# UNITED STATES PATENT AND TRADEMARK OFFICE

APPLICATION NO.	FILING DATE	FIRST NAMED INVENTOR	ATTORNEY DOCKET NO.	CONFIRMATION NO.
10/717,401	11/19/2003	Randall J. Huebner	ACM 354	7508

<b>Office Action Summary</b>	Application No.	Applicant(s)	
	10/717,401	HUEBNER ET AL.	
	Examiner	Art Unit	
	Anu Ramana	3733

## DETAILED ACTION

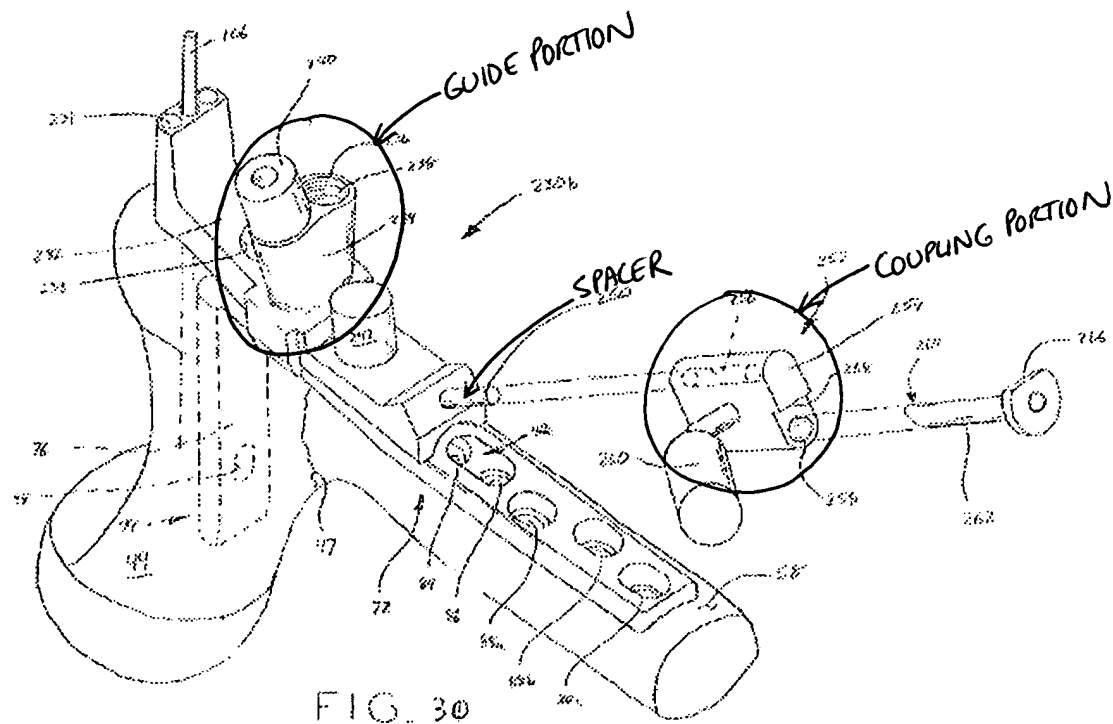
Aikins et al. disclose a bone plate 74 with predefined positions or holes (82, 88); a guide portion 230b; a coupling portion 252 connected to the guide portion and configured to be disposed across the bone from the guide portion; a removably attached drill sleeve or cannula or guide element 240; threads or "detent mechanism" 238 in the guide portion to restrict movement of the guide element; a connective feature 98; and a spacer portion or "one additional connective feature" 250 connecting the coupling portion to the guide portion (Figs. 30-31, paras [0089]-[0092]). See marked up Figure 30 below.

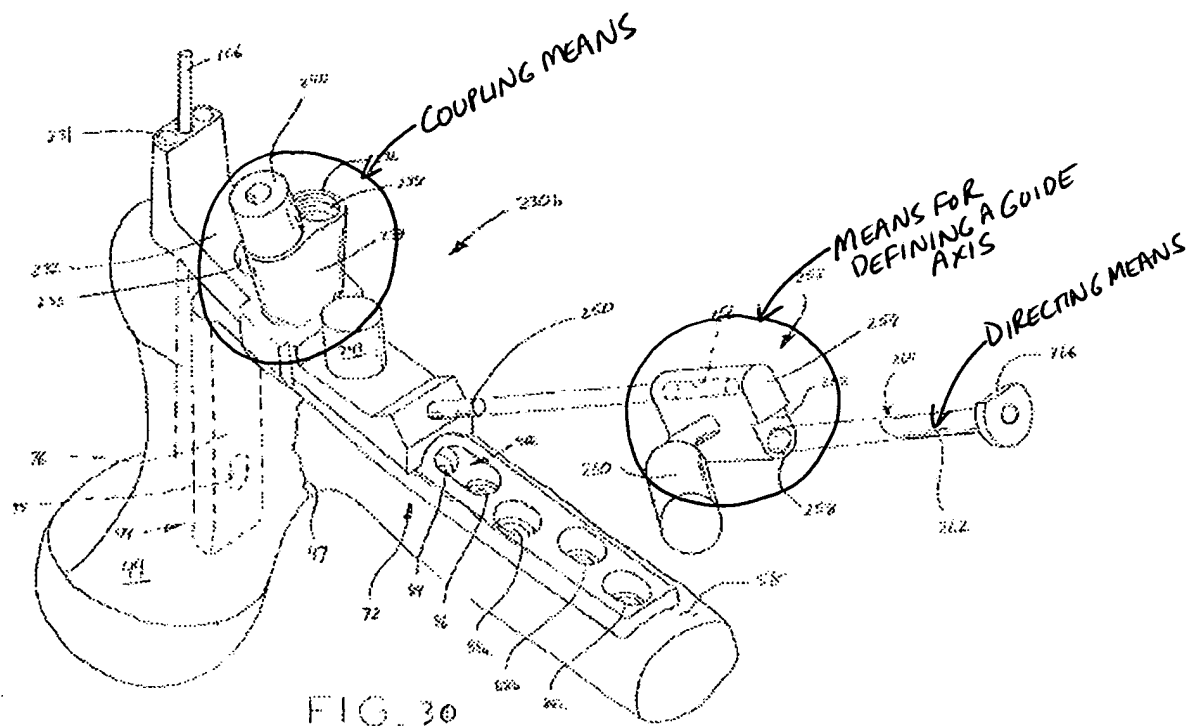
Aikins et al. disclose a bone plate 74; means for coupling to the bone plate; a means for defining a guide axis that extends through the bone (252); a means for directing a bone screw through the bone and into an opening 98 in the bone plate (Figs. 30-31, paras [0089]-[0092]). See marked up Figure 30 on the following page.

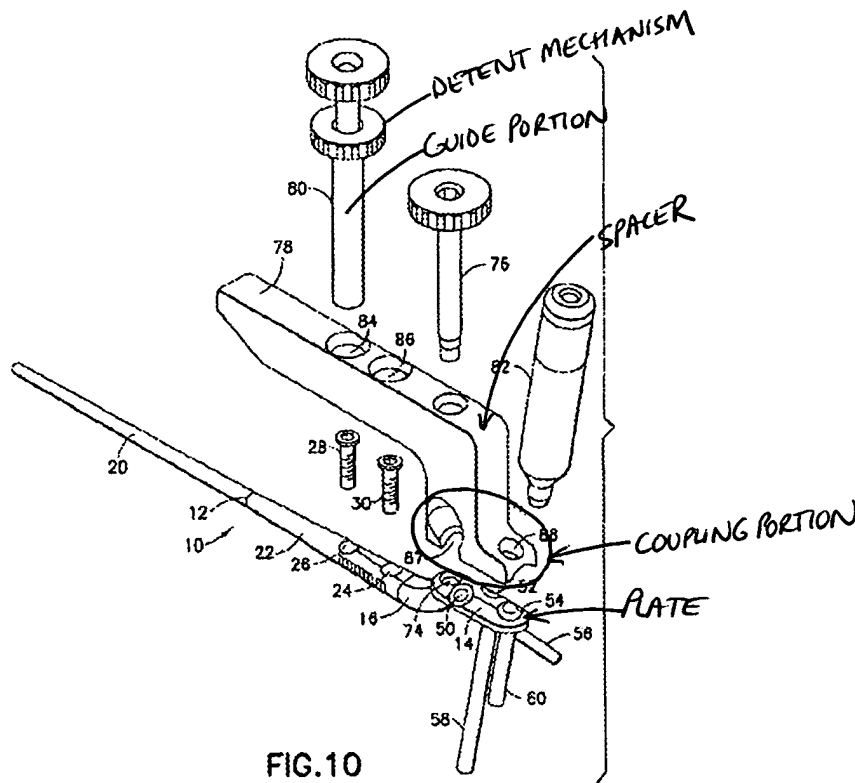
Orbay et al. disclose a device including: a coupling portion connected to a bone plate; a guide portion 80 connected to the coupling portion and configured to be disposed across the bone from the coupling portion; a plurality of connective features (24, 26, 74); and a spacer portion (Fig. 10, col. 4, lines 58-67 and col. 5, lines 1-40). See marked up Fig. 10 on the following page.
